Reliability Analysis Update

Transmission Expansion Advisory Committee

Tuesday, August 10, 2021

AEP Transmission Zone B3139 – B3141, B3220 Replacement

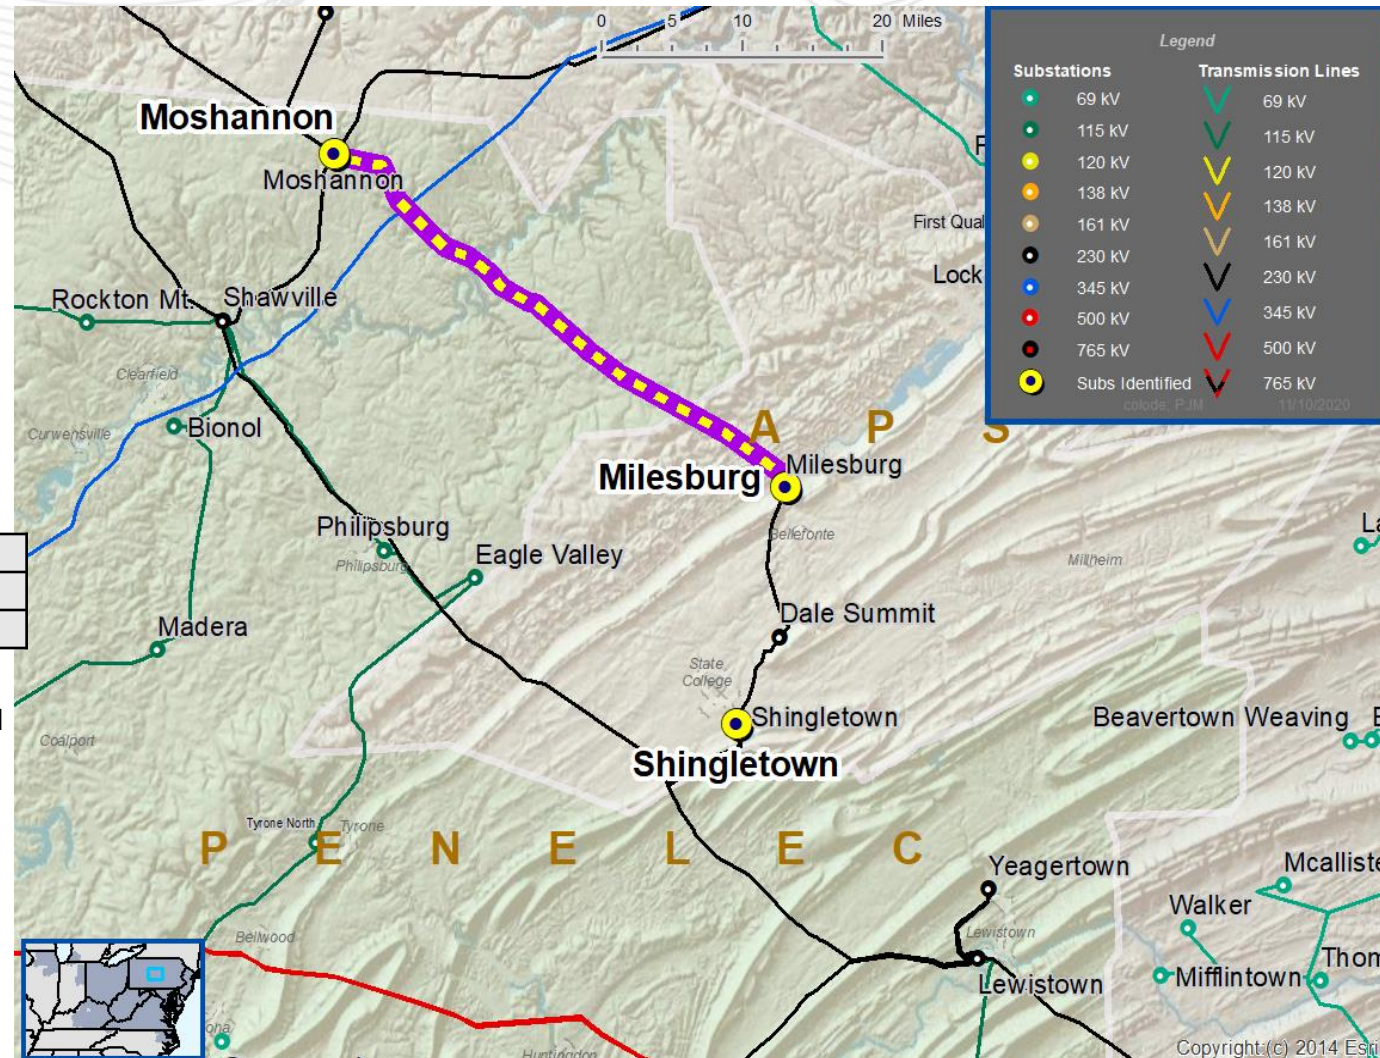
Problem Statement: In the 2020 RTEP 2025 Winter N-1-1 analysis the loss of the Milesburg - Moshannon 230 kV line followed by the loss of the Shingletown #82 230-46 kV transformer results in a voltage drop violation at the Shingletown 230 kV bus of 12.5%.

Violations were posted as part of the 2020 Window 1: FG# APS-VD45, APS-VD46

At Shingletown Substation (APS Zone) convert the 230 kV station to a six breaker ring bus. Re-use and re-install the existing capacitor. Install SCADA control. Install new wave traps on Shawville and Dale Summit line exits.

At Shawville Substation (PN Zone) replace the wave trap and substation conductor.

At Lewistown Substation (PN Zone) install direct transfer trip relaying to be compatible with the new Shingletown ring bus relaying.
